Staff Report:

*The Applicant has applied for Zoning Map Amendment, requesting that one parcel (PIN # 413102D158) totaling 0.81 acres be rezoned from Single-Family Detached Structure Residential (R-2) to PD Planned Development to allow for the establishment of a drive-thru convenience retail use. *Please refer to the Applicant's statements, plans, and other application enclosures.*

Case# 3-22-Z
Date 11-1-2022

**SITE & LANDSCAPE PLAN
LOT #46 OF REPLAT OF LOT 21
OF
WHITMORE WOODS SUBDIVISION
UNION TWP., CLERMONT CO. OHIO**

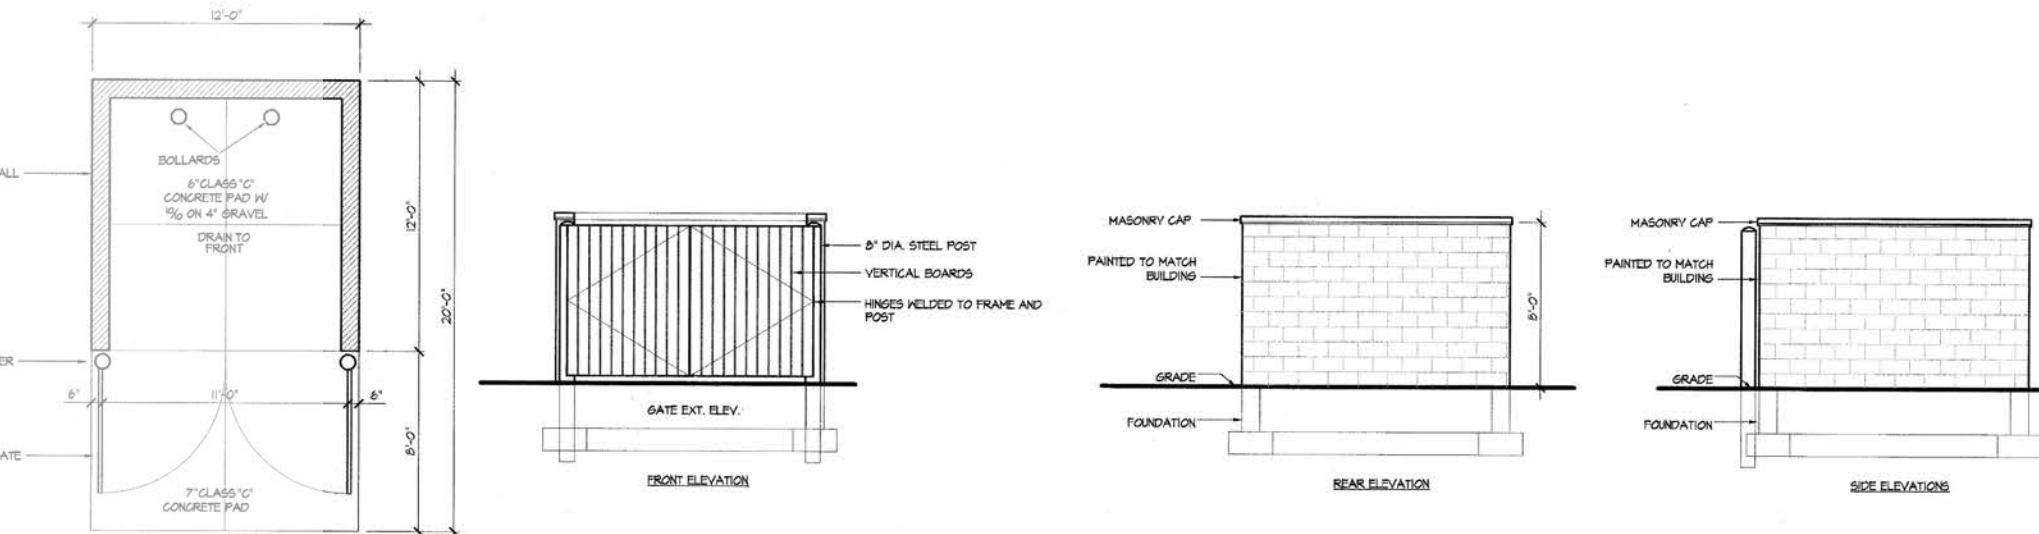
At present, the current plan information is unclear / noncommittal regarding the type of building that is proposed for the drive-thru convenience retail use, as the pictures provided do not match the descriptions provided to-date. There has been no signage information submitted; however, the Applicant representatives have verbally indicated that they would create signage in accordance with any standards set forth by the Township during the Zone Map amendment process. The proposed landscaping and bufferyard sizes to the south and along the west frontage are also unclear and less significant at this time, compared to the Township's standards and regulations, and staff would recommend some additional area and improvements if this project were to move forward to provide more suitable transitional areas and to mitigate potential noise and lighting and visibility issues.

- 3) The Applicant would need to enhance the proposed landscaping and bufferyard areas to the south and along the west frontage. Additionally, the landscaping buffer along the north, south, and east property lines should be marked as preservation areas, and any vegetation disturbed should be repaired, supplemented, or replaced. This is an item that can be addressed administratively by staff.

- 4) All lighting would need to be limited to wall pack lighting, downward directed, and of sufficient intensity to illuminate without projecting onto the adjoining residential property. **At present, the Applicant has indicated that the proposed use would operate between 9am and 9pm. With these hours, the efforts needed to address potential light trespass would be seasonal and would be estimated to be 1-4 hours.*

- 6) There are several additional items or notes such as dimensioning of certain improvements, distance to and identification of the nearest street intersection, adjacent parcel land uses and zoning (including those across the road), building coverage percentage, a note regarding floodplain status, a better vicinity map, etc. that would need to be added or changed and verified for the development plan to conform with the Union Township Zoning Resolution. The statement required on PD plans per Section 684, item 2 would also need to be added. If this project would receive a favorable recommendation, these items could be addressed administratively, if deemed appropriate.
